Item # 5  
MCPB 04-20-06

DATE: 04/07/06  
TO: Montgomery County Planning Board  
VIA: Rose Krasnow, Chief *RK*  
Robert A. Kronenberg, Acting *RK*  
Supervisor  
FROM: Development Review Division  
Laxmi Srinivas, Senior Planner *LS*  
Development Review Division  
(301) 495-4584

REVIEW TYPE: **Site Plan Review**  
CASE #: **820060070**  
PROJECT NAME: Rock Creek Woods  
APPLYING FOR: Approval of 30 townhouses including four MPDUs on 5.69 acres of land in the RT-8 Zone

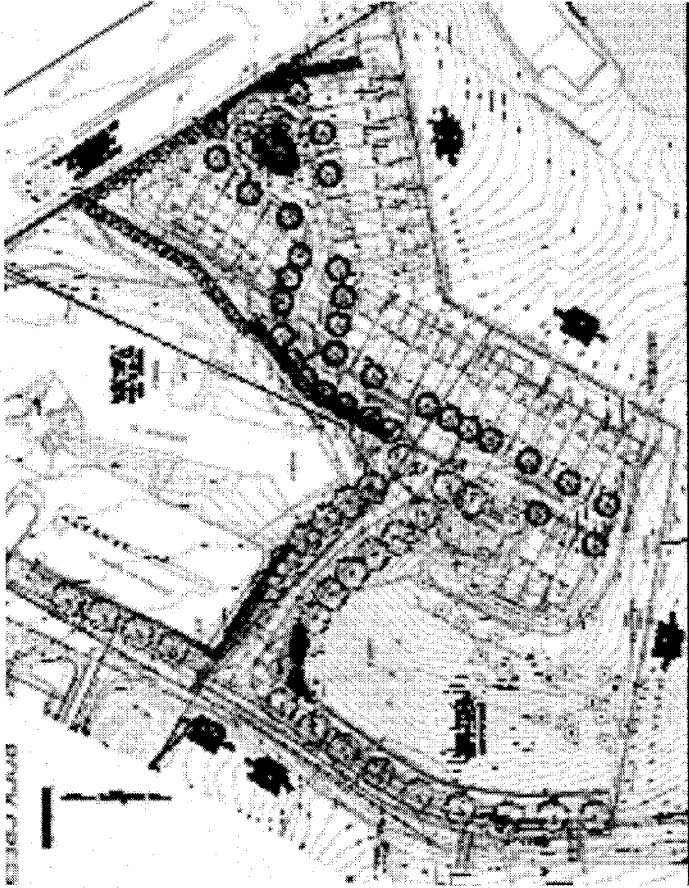
The applicant is proposing a total of 30 townhouses, including four MPDUs on 5.69 acres of land. Access to the property is from a single entrance along Baltimore Road. The townhouses are proposed in the north and northwestern portions of the property and, the forest conservation area is proposed in the northeastern portion of the property. A stormwater management pond is proposed along the eastern side of the proposed townhouses. A recreational area consisting of a picnic area, an open play area and a gazebo with four benches is proposed within a cul-de-sac along the northwestern portion of the property. The MPDUs are dispersed throughout the development. Visitor parking is proposed in two locations. Retaining walls are proposed along the western and southern sides of the townhouse development and along Baltimore Road.

The access road from Baltimore Road and the internal streets are proposed as private streets with a 20-foot-wide pavement and five-foot-wide sidewalks. A four-foot-wide trail connection is provided along the northern portion of the site to connect to Rock Creek Park. Direct pedestrian connections are not proposed from within the site to the adjacent Rockville High School and the synagogue because of steep slopes and security concerns. A five-foot-wide sidewalk is proposed from the access point on Baltimore Road to the south, across the synagogue frontage, to the northernmost access drive into Rockville High School. This sidewalk will provide a safe pedestrian path along Baltimore Road.

Trees are provided along the access road, the internal streets and along Baltimore Road. The entrance to the site and the recreational areas are landscaped with a combination of trees, shrubs and perennials. Pole mounted light fixtures are proposed along the access road and internal streets.

The 0.08-acre stream buffer along the eastern portion of the property will be impacted by the removal of 0.07 acres of forest in the public utility easement that parallels Baltimore Road. The removal of the forest is necessary to provide a clear path for utilities. There are no other proposed encroachments into the stream buffer.
